Kenwood TS 2000 (TS-2000 TS2000 TS-2000X TS-B2000)

Kenwood TS-2000 (TS 2000) PLL Unlock Problems & Solution

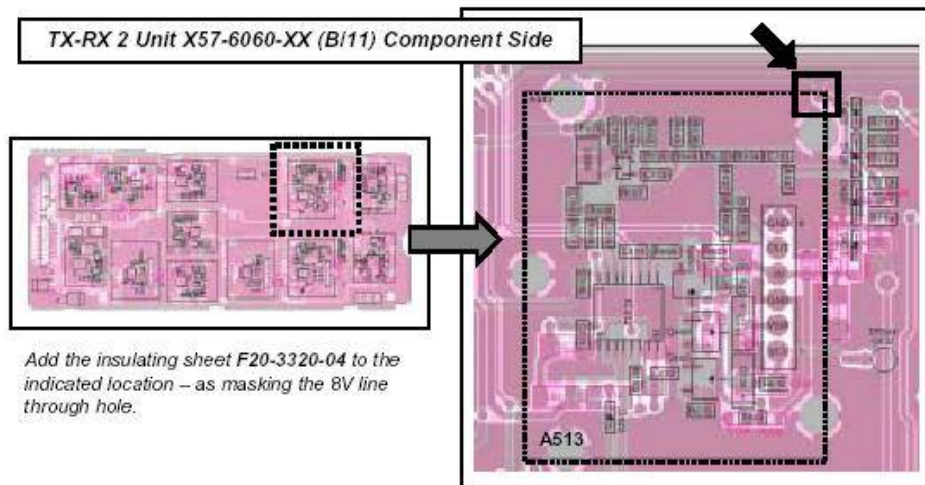
1. One is that the trimmer cap goes intermittant,
2. One that we resoldered the VCO and
3. Another that the shield plate was hitting the positive supply point. Attached is a picture of the shield short proble. With you radio turning off that may be the problem. Even though it seems unlikely that a short like this can be intermittant, it can:

PA1DYK did steps 2 and 3, and on top of that noticed that there was a lot of raisin on the contact points of the PCB and chassis on places where they should have provide ground connectios and he removed this as well.

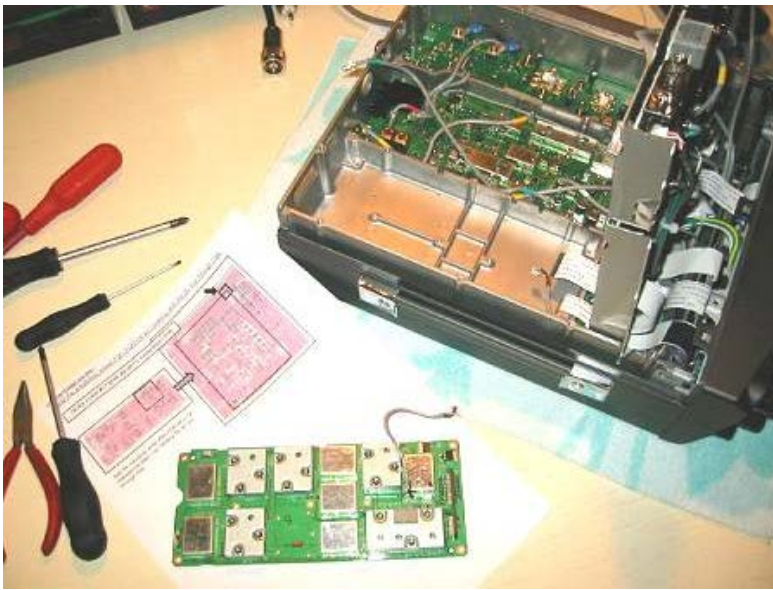
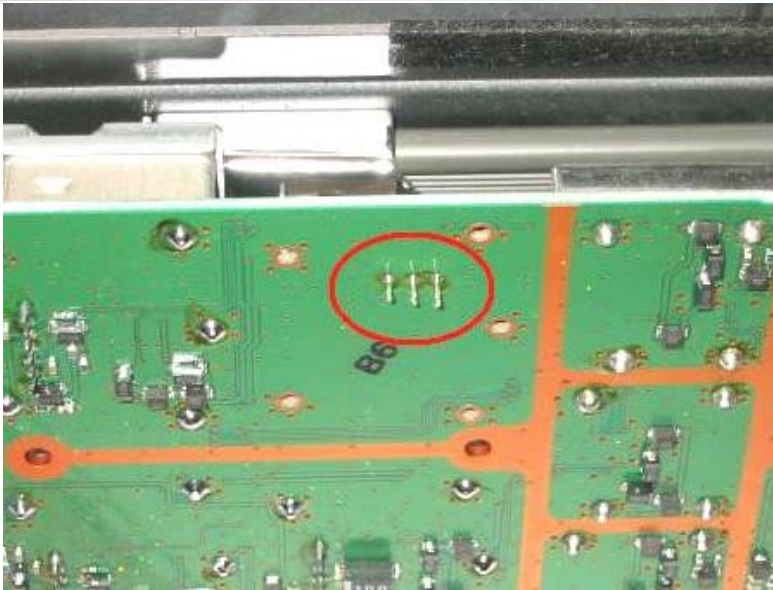
While inspecting the PLL / VCO PCB immediately we (PE1RXJ & PA3GUO) noticed the long leads of the ceramic filter that were not cut off properly (see red circle), and were very close to create a short between them and the chassis (ground). We have cut these leads back to an acceptable length.

More leads were present that were too long, eg the coax connector ones, and all were cut.

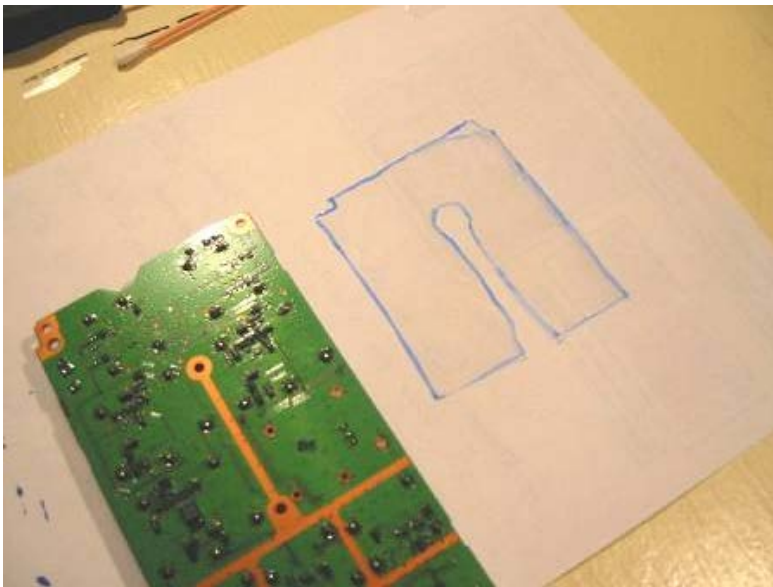
Just to make sure, we then made from plastic a foil that would prevent any short between the PCB solder points and chassis, for the photo we put a blue color at the borders:
(note that we made a cut to ensure ground connections in the middle of the PCB still make contact)

X57-606 (B/11) Component side

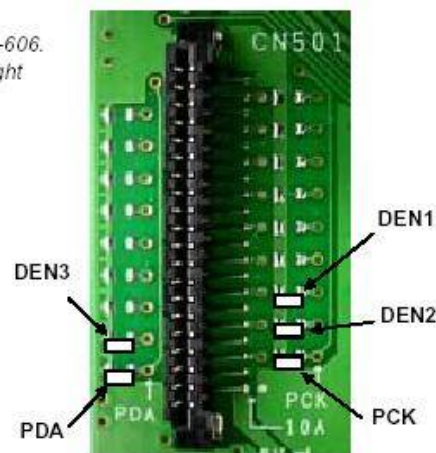
<SYMPTOM>
When the operating frequency of 430/440 MHz band is moved by main dial while transmitting, the PLL circuit of 430/440 MHz band is unlocked intermittently.

<COUNTERMEASURE>
The following 5 parts have been added to TX-RX2 unit X57-606. There are spare lands beside CN501. Please refer to the right figure and attach the parts.

Spare land name	Parts No.
PDA	CC73GCH1H220J (22pF)
PCK	CC73GCH1H220J (22pF)
DEN3	CC73GCH1H220J (22pF)
DEN2	CC73GCH1H220J (22pF)
DEN1	CC73GCH1H220J (22pF)
